Proposed changes to the King Charles III England Coast Path at East Hill to Cowden Parva

Natural England's Variation Report to the Secretary of State

Coastal Access Variation Report VR19
December 2023

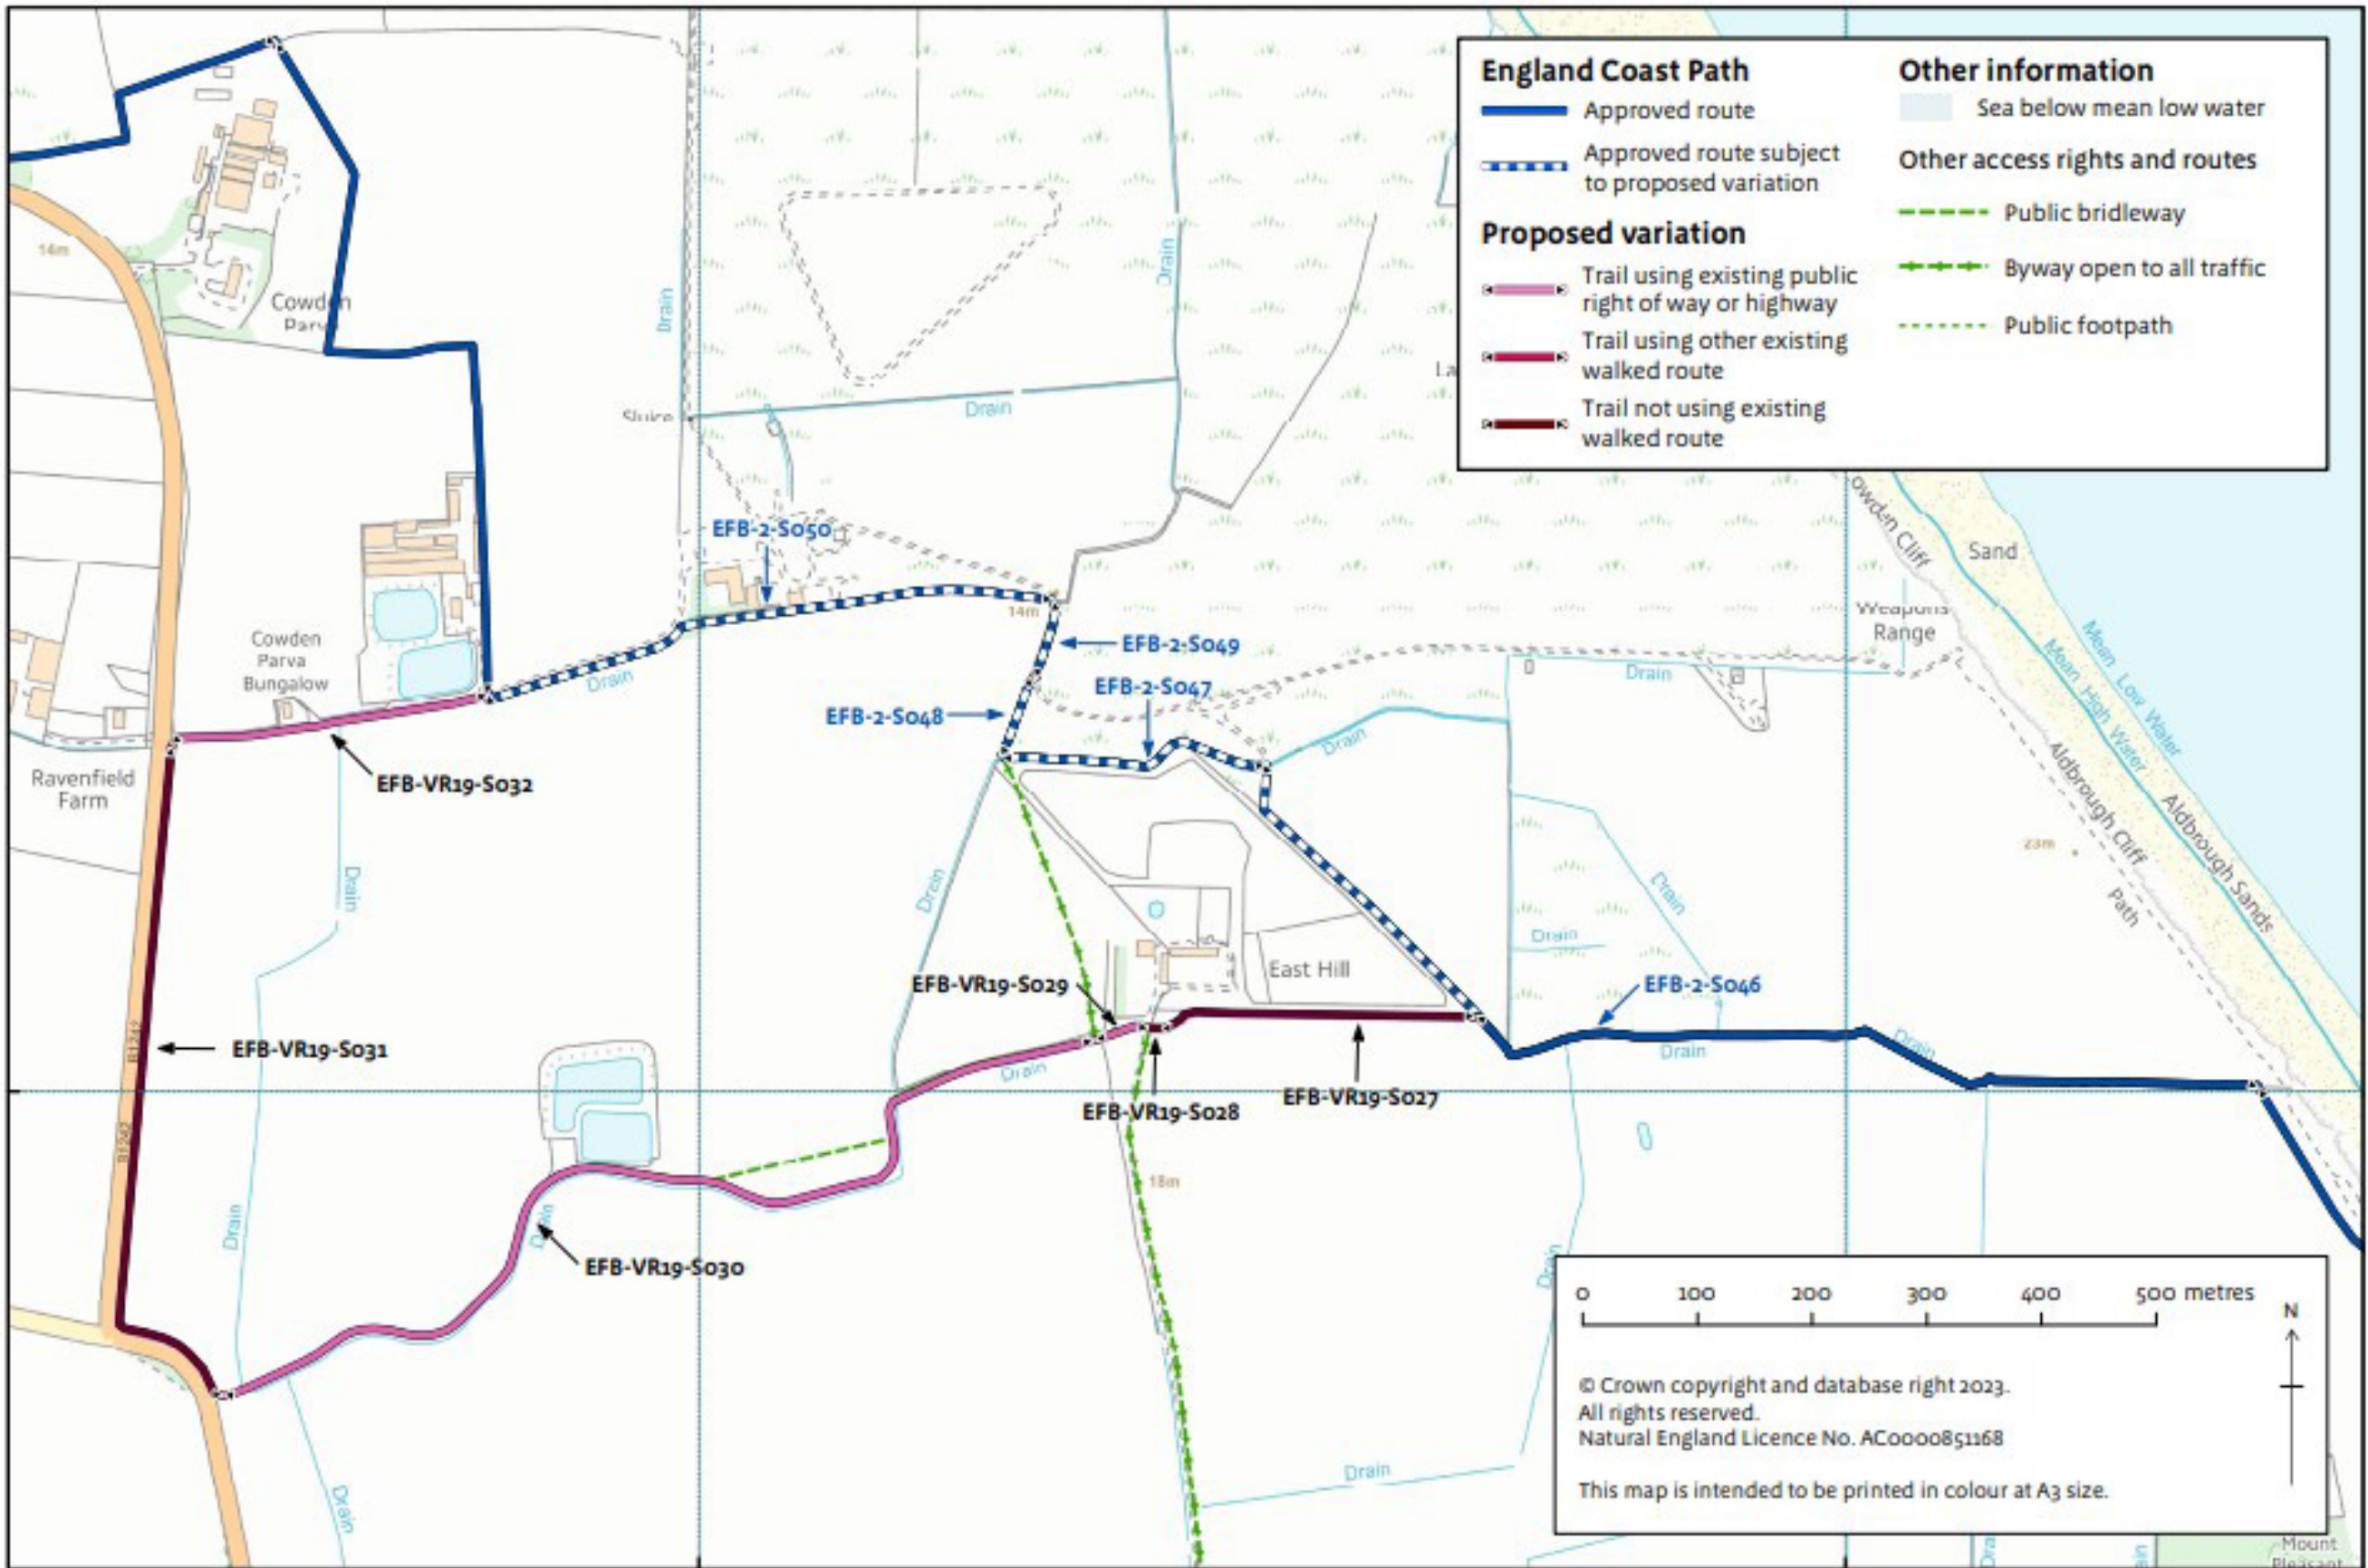
2.1.1 The land to the north of the approved trail alignment is the Cowden Former Air Weapons Range. Natural England have been requested by the Defence Infrastructure Organisation to move the path on the southern edge FAWR boundary due to operational land management requirements.

2.1.2 Our proposal (see map VR19a) is to re-route the path shown as EFB-2-S046 to EFB-2-S050 in our original report. The Original route passed behind East Hill and followed the outer edge of the Former Air Weapons Range (FAWR) at Cowden.

2.1.3 The route proposed initially follows the southern boundary of the residential property at East Hill before joining the existing byway for a short distance and then a public bridleway to the B1242. At this point the trail turns northward and follows the field margin north, with the existing hedgerow separating it from the road. At the northern end of the field, it joins the access road to Cowden FAWR and re-joins the original approved route.

2.1.4 This variation adds the arable field it encloses to the seaward coastal margin.

- Would follow a newly created section of path on the arable field margins at EFB-VR19-S027 and EFB-VR19-S031.
- Follows existing walked routes at EFB-VR19-S032, including public rights of way including a byway at EFB-VR19-S029 and a public bridleway at EFB-VR19-S030.

- Extends for a length of 2000 metres at a maximum of 1150 metres landward of the approved route.
